7.7 Control Systems Not Required for Safety

The information in this section of the reference ABWR DCD, including all subsections and figures, as modified by the STP Nuclear Operating Company Application to Amend the Design Certification rule for the U.S. Advanced Boiling Water Reactor (ABWR), "ABWR STP Aircraft Impact Assessment (AIA) Amendment Revision 3," dated September 23, 2010 is incorporated by reference with the following departures and supplements.

Figure 7.7-11 Simplified Functional Diagram of the Automatic Power Regulation System

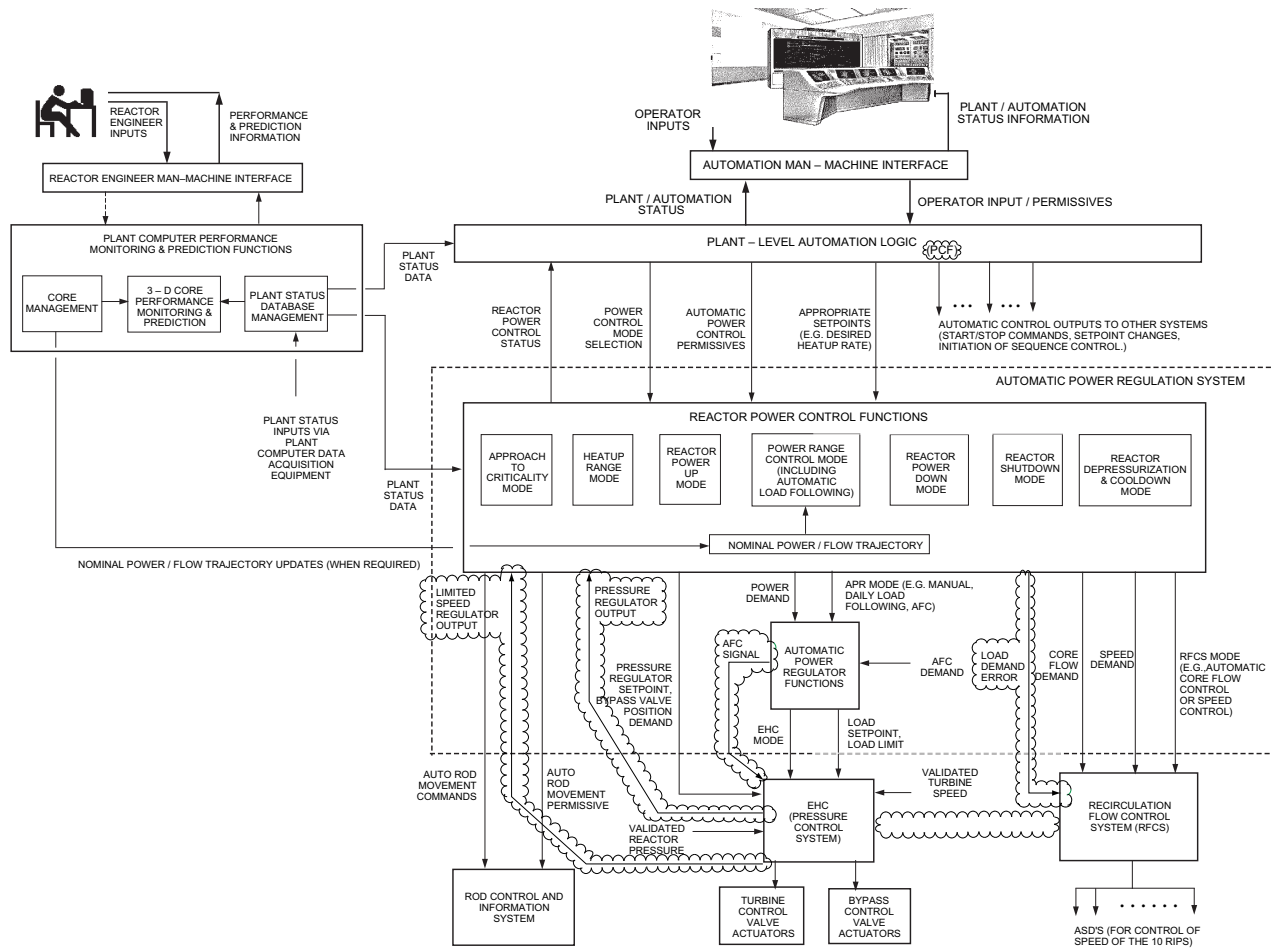
STD DEP 7.7-20 (Figures 7.7-5, 7.7-7, 7.7-11)

STD DEP 7.7-24 (Figures 7.7-11, 7.7-12, 7.7-13)

The primary objective of the Automatic Power Regulator (APR) System is to control reactor power during reactor startup, power generation, and reactor shutdown, by appropriate commands to change rod positions, or to change reactor recirculation flow. The secondary objective of the APR System is to control the pressure regulator setpoint (or turbine bypass valve position) during reactor heatup and depressurization (e.g., to control the reactor cooldown rate). The APR System consists of redundant process controllers. Automatic power regulation is achieved by appropriate control algorithms for different phases of the reactor operation which include approach to criticality, heatup, reactor power increase, automatic load following, reactor power decrease, and reactor depressurization and cooldown. The APR System receives input from the ~~plant computer~~ PCE, the Power Generation Control System (Subsection 7.7.1.5.42), the Steam Bypass and Pressure Control System (Subsection 7.7.1.8), and the operator's control console. The output demand signals from the APR System are to the RCIS to position the control rods, to the RFC System to change reactor coolant recirculation flow, and to the SB&PC System for automatic load following operations. The ~~PGS~~ PGCS performs the overall plant startup, power operation, and shutdown functions. The APR System performs only those functions associated with reactor power changes and with pressure regulator setpoint (or turbine bypass valve position) changes during reactor heatup or depressurization. A simplified functional block diagram of the APR System is provided in Figure 7.7-11.
